**CMD 26-H103.2**

**Written Submission from  
Dr. Frank Greening**

Application to amend the licensing basis for Bruce A and B nuclear generating stations to operate Units 7 and 8 pressure tubes beyond 300,000 effective full power hours

**Hearing in Writing**

Figure 1:

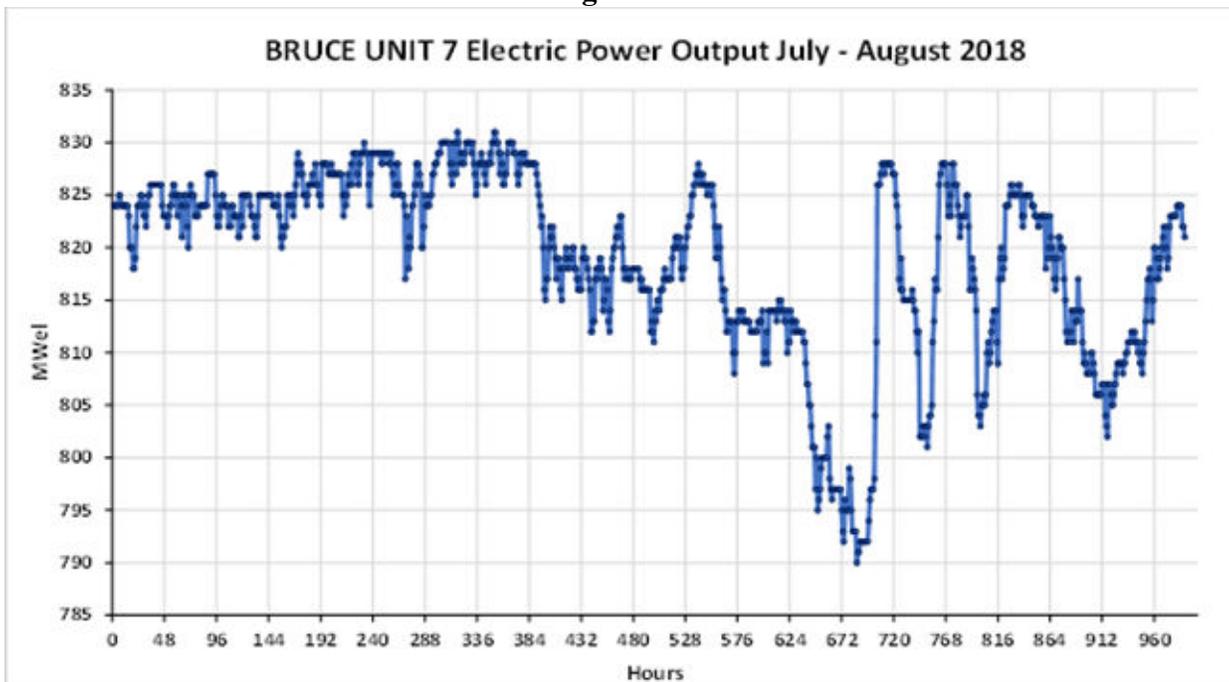
However, it turns out that nuclear reactors are generally unable to maintain constant electrical power output due to variable conditions such as the circulating water temperature. As a consequence, to accurately account for such changes, hourly generator output power data, such as the data published by the Independent Electricity System Operator (IESO) are of great value. Figure 1, below, is an example of the IESO power output data for Bruce Unit 7 plotted for an arbitrarily selected date and time interval. It shows Unit 7's August 2018 output varying between a maximum value of 831 MW<sub>el</sub> and a minimum of 790 MW<sub>el</sub> over a time interval of about 40 days.

Such data provide a very detailed, full accounting, of a nuclear reactor’s power output over a selected time interval.

**Figure 2: Bruce Unit 7 Diametral Expansion**

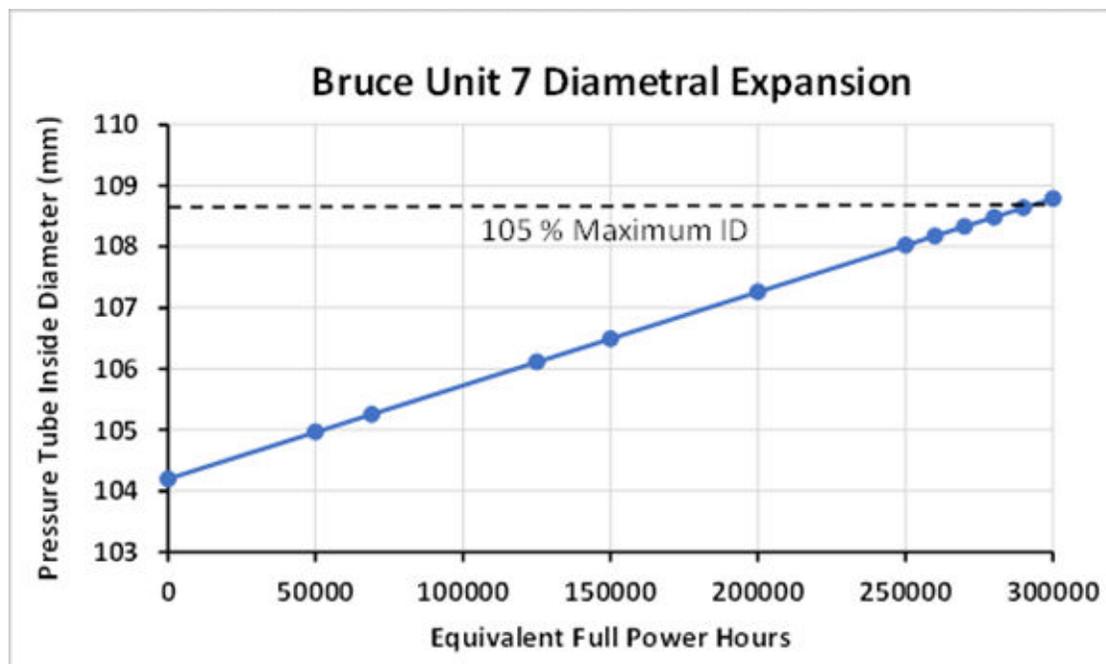
A plot of the predicted maximum diametral expansion data for Bruce Unit 7 pressure tubes is presented in Figure 2, below, which shows that this Unit will have already exceeded the 108.6 mm diameter limit at 300,000 EFPH. One therefore has to ask if Bruce Power can guarantee that Bruce Unit 7 will not be subject to fuel sheath dry-out if operated beyond 300,000 EFPH?
